Decision Report

Application for Licence

Licence Number	L9455/2024/1
Applicant	Newmont NOL Pty Limited
ACN	009 221 505
File number	DER2024/000383
Premises	Havieron Project
	Legal description
	Mining tenement M45/1287
	EAST PILBARA
	As defined by the premises maps attached to the issued licence
Date of report	13 January 2025
Decision	Licence granted

Figure 3: Distance to sensitive receptors

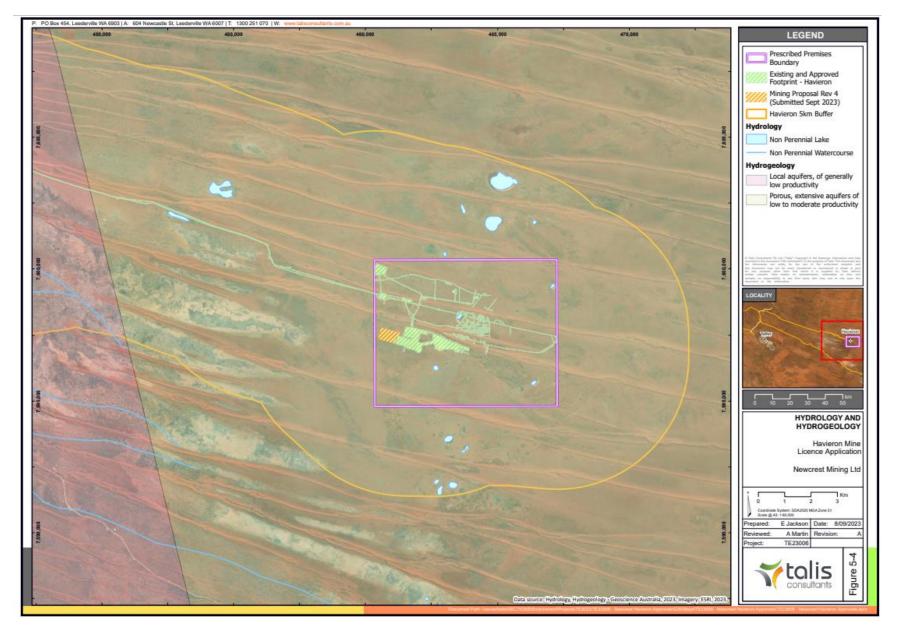
Table 5: Groundwater monitoring	HAEPMB01 was grouted to surface in July 2022 and not available as a monitoring point (this information was provided to DWER).	Noted and table updated to reflect correct monitoring bores. Figure 3 has been updated.
	Additional groundwater monitoring bores are available as compliance locations to replace HAEPMB01 and are shown below (figure provided).	Table 5 has also been amended to link bores to Figure 3 which depicts these locations.
